ADDENDUM #1

Project: New Elementary School, Maynard School District
Project No.: 14-19
ARKANSAS DPSAFT #: 1415-6102-001
Date: January 4, 2017
From: Dille & Traxel, LLC
4061 Highway PP, Suite 2
Poplar Bluff, MO 63901

New Elementary School, Maynard School District

STONE MEDALLION

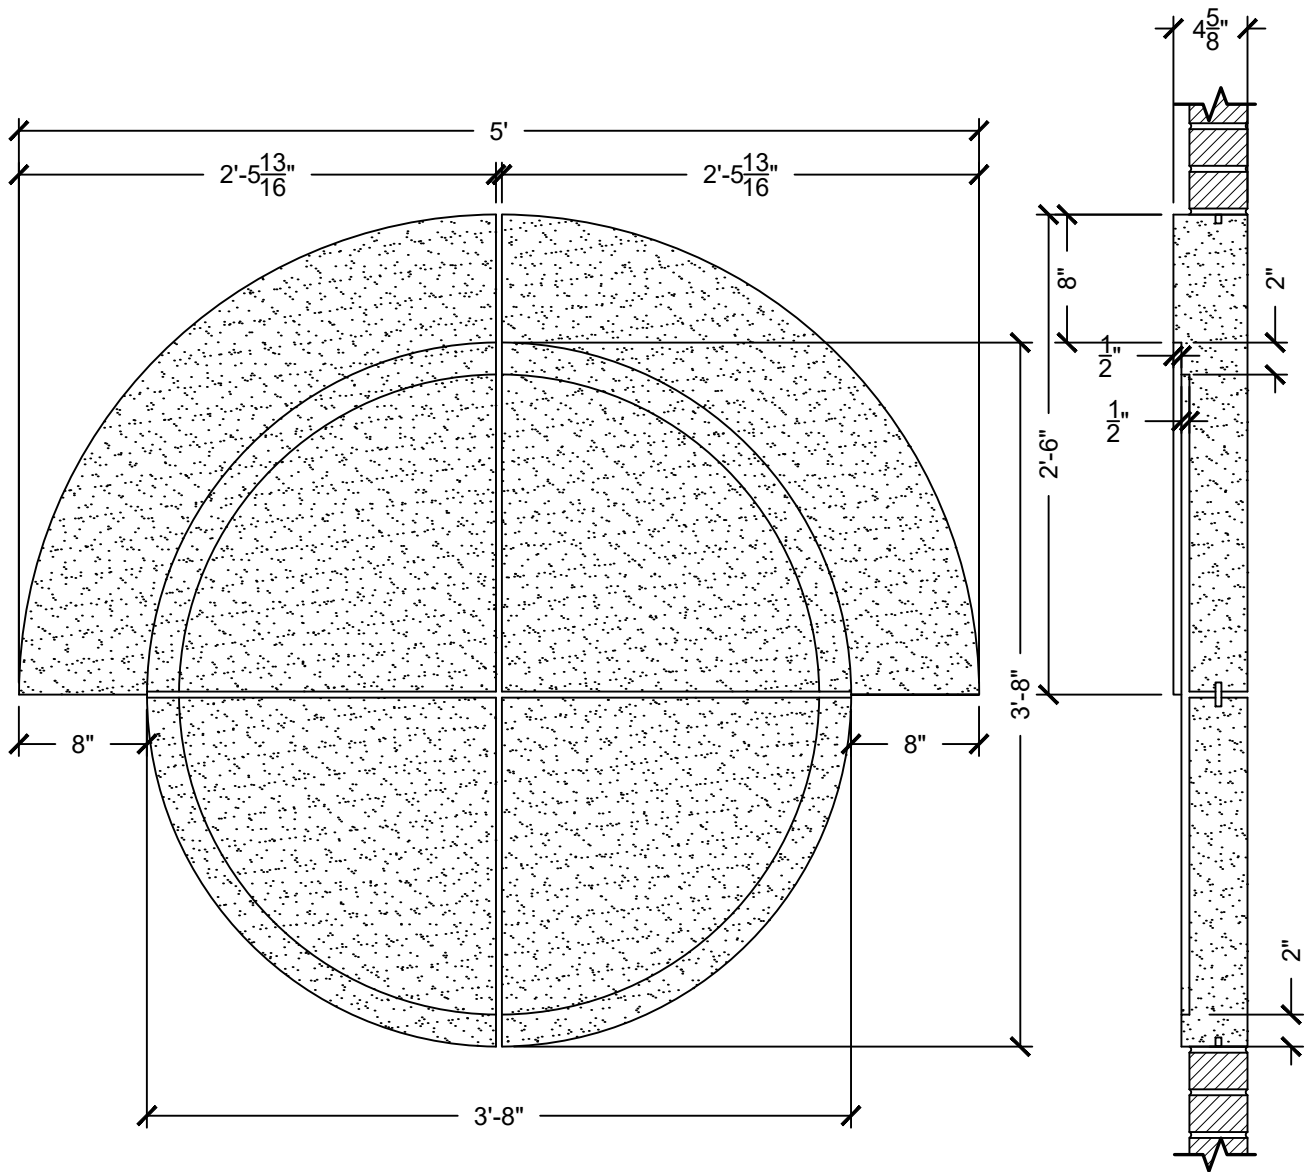
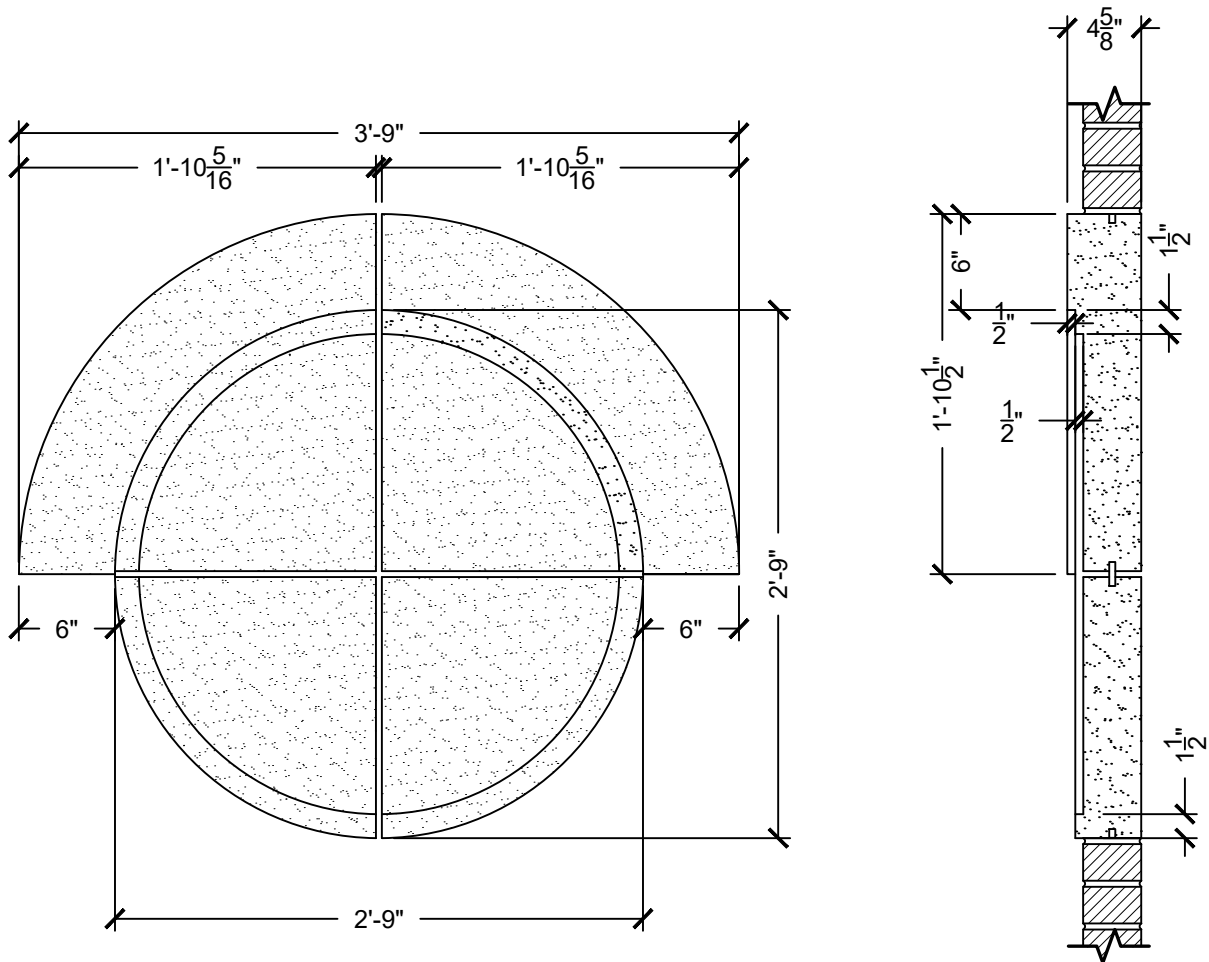
14. **Clarification** - Reference A3.0 - See included drawings for stone medallions. 3'-8" dia. medallion is located at the North end of gabled building; the 2'-9" dia. medallion is located at the entry. (2 pages)

DATE: 10-27-2016
 SHEET TITLE: PROPOSED UTILITY PLAN
 JOB NO.: 14-19
 SHEET

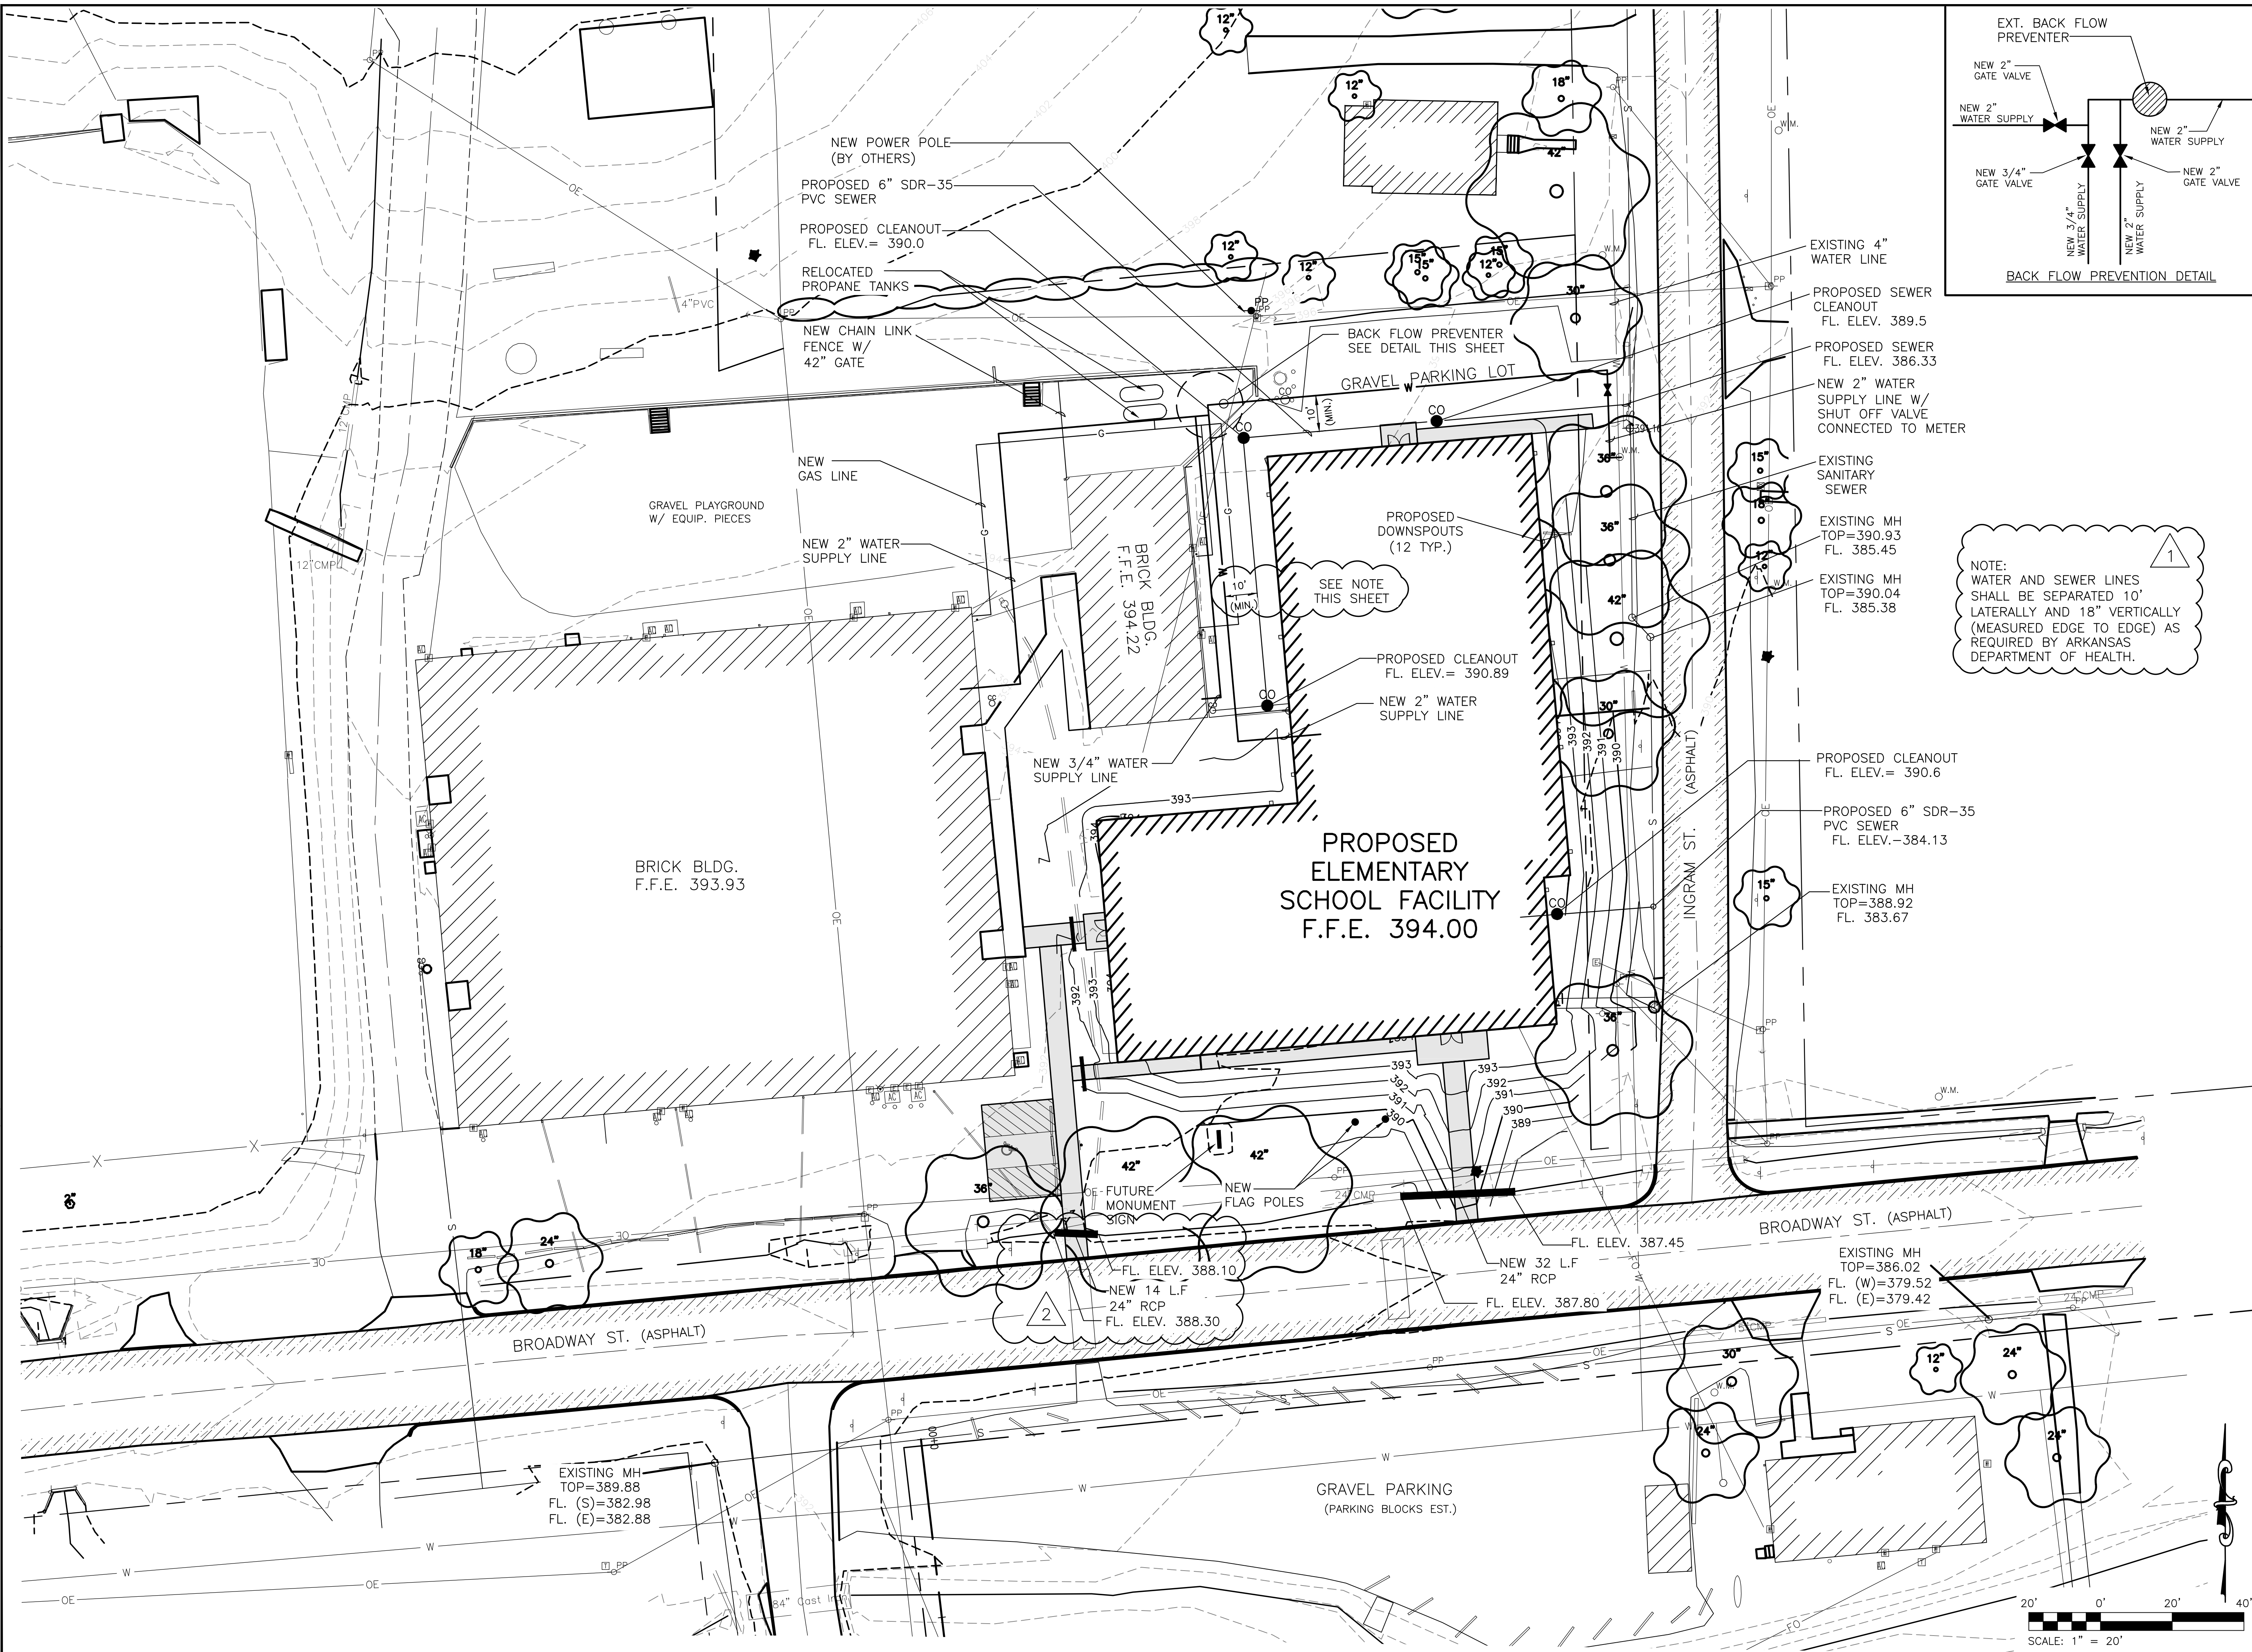
17. Refer to included drawing from Horner & Shifrin (one drawing, C4).
18. Refer to included Addendum 01 from Toth & Associates (one sheet)
19. Refer to included MPE Addendum #1 from Strickland Engineering (ten sheets, including one drawing, E1.1).

| REVISIONS | |
|-----------|--------------------------|
| 01-03-17 | ADD RCP |

FLOOR PLAN - POWER WIRING
SCALE: 1/8" = 1'-0"

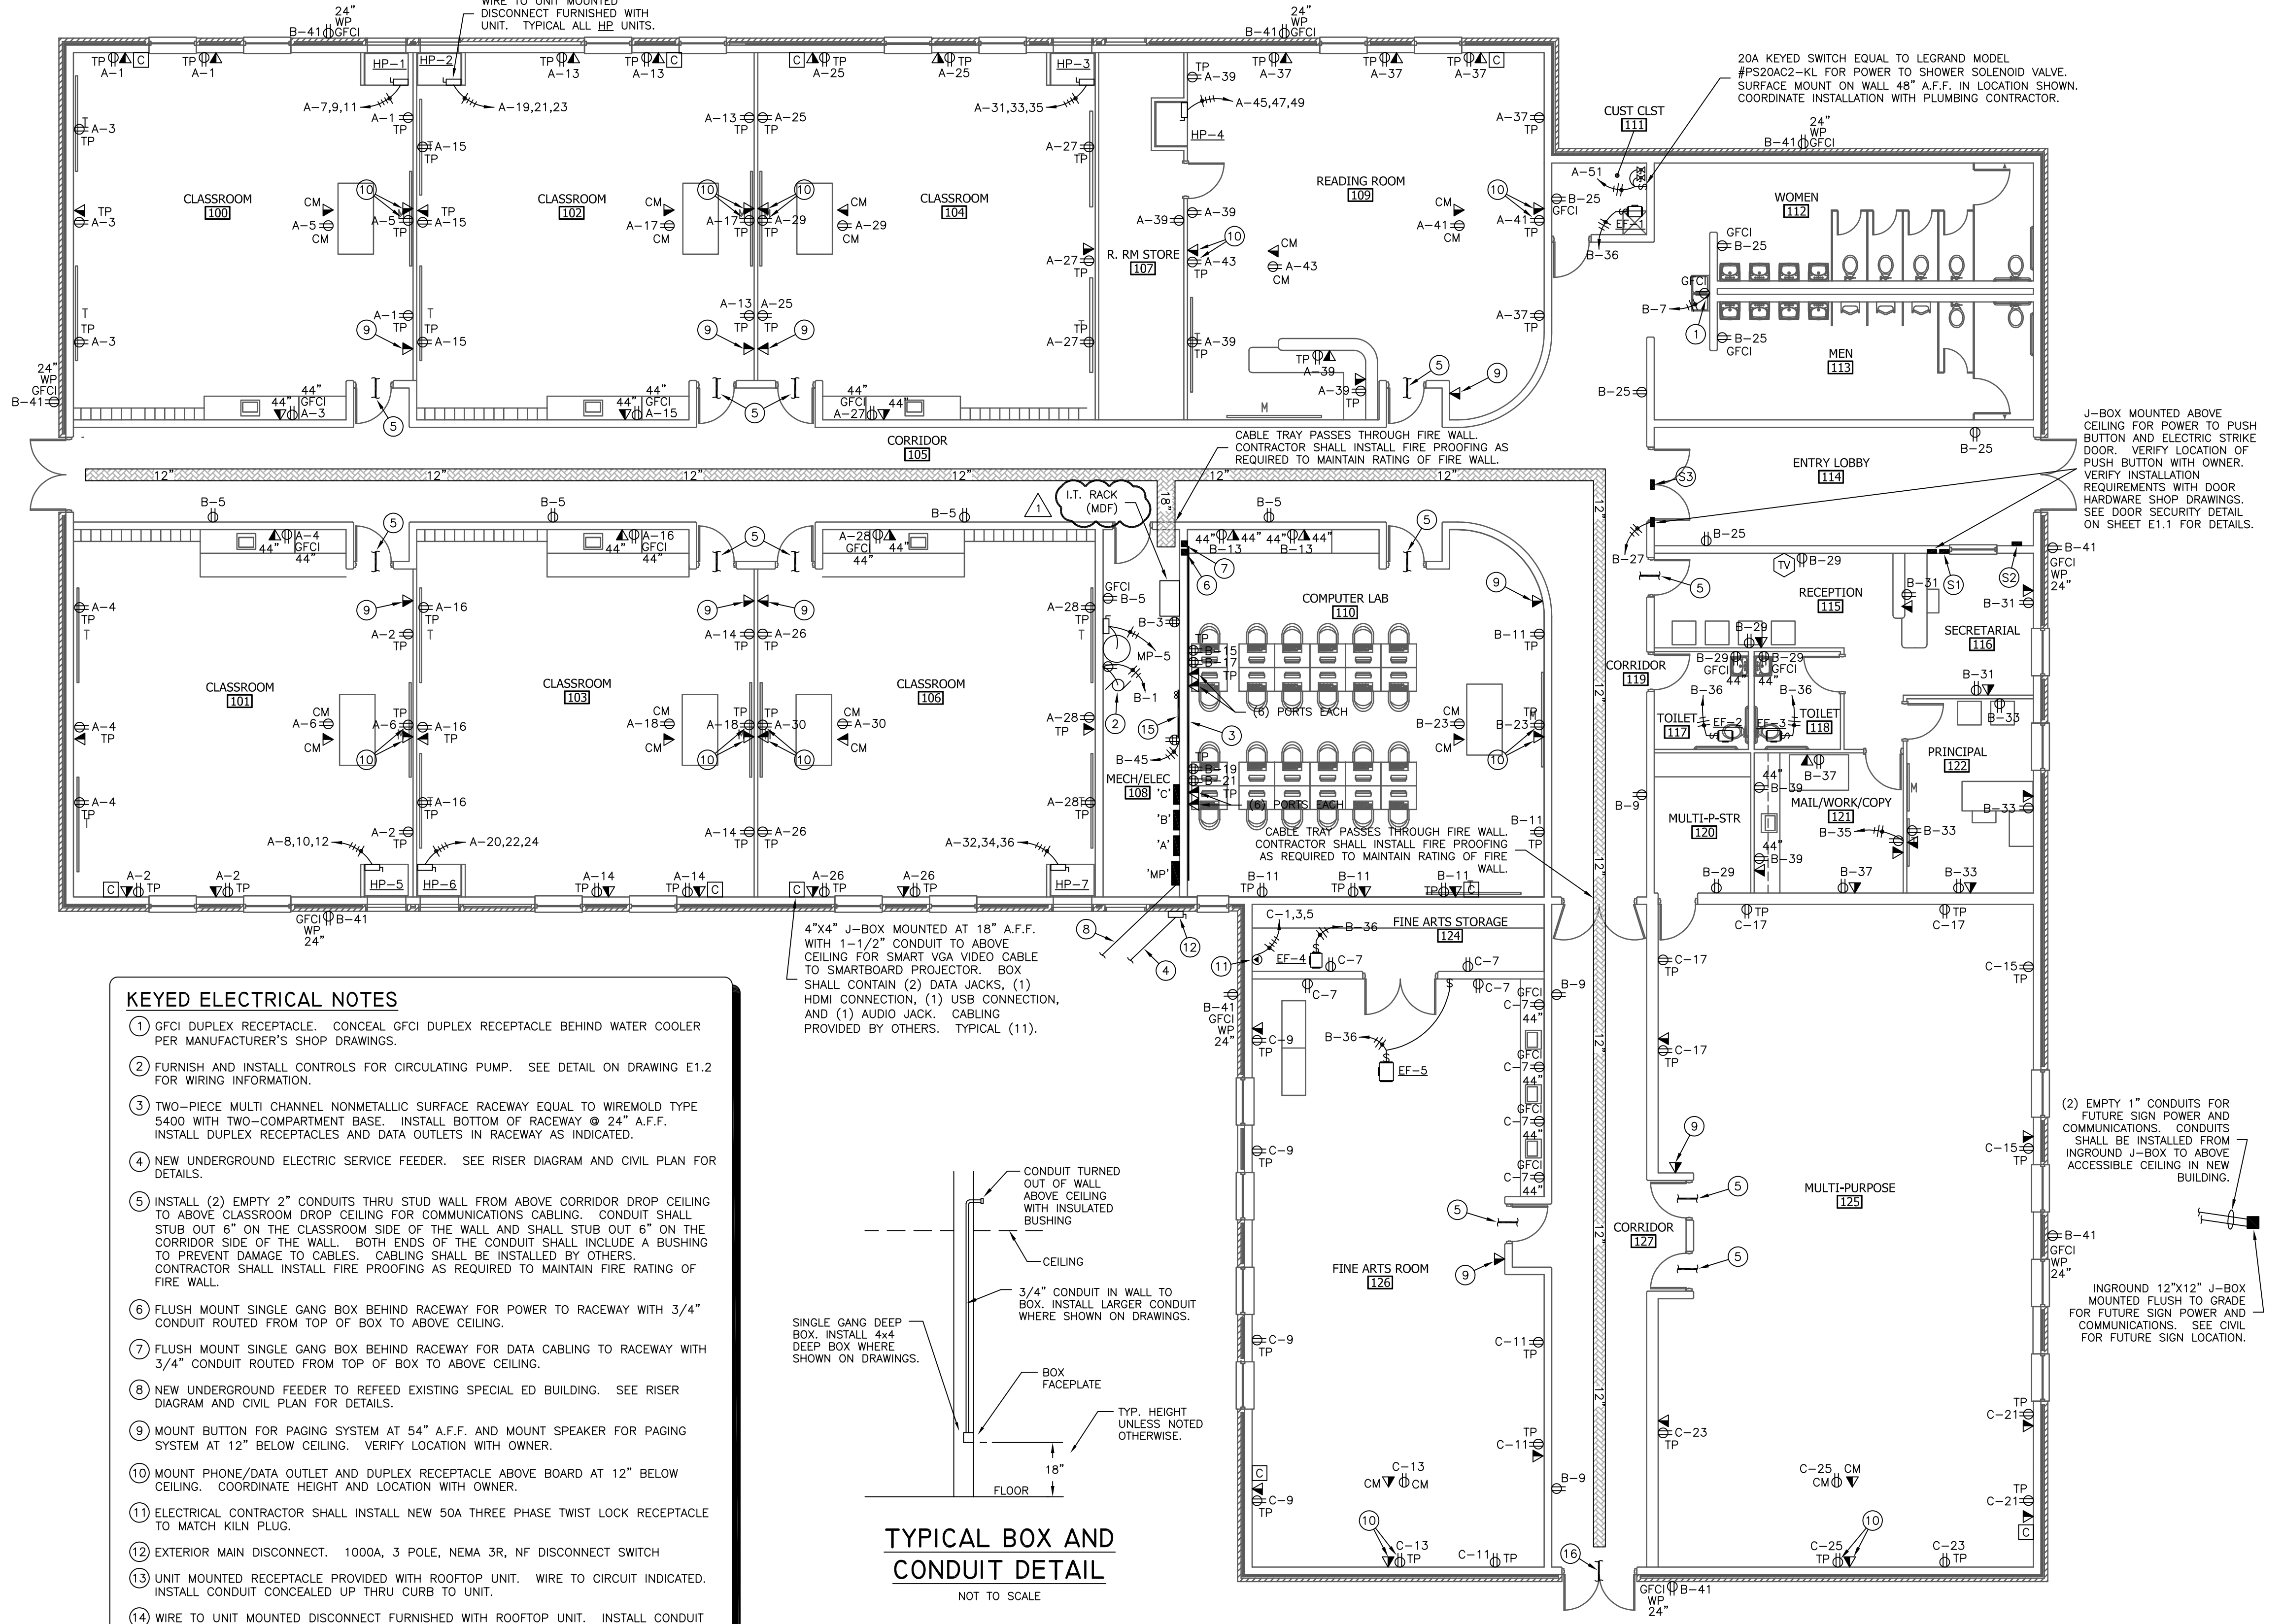
| ITEM | SECTION | DESCRIPTION |
|------|---------------|---|
| 3 | E1.1 | <p>MODIFICATION - Notes were modified to indicate that the telephone/data system is the contractor's responsibility and shall be included under the base bid. See attached drawing E1.1.</p> |
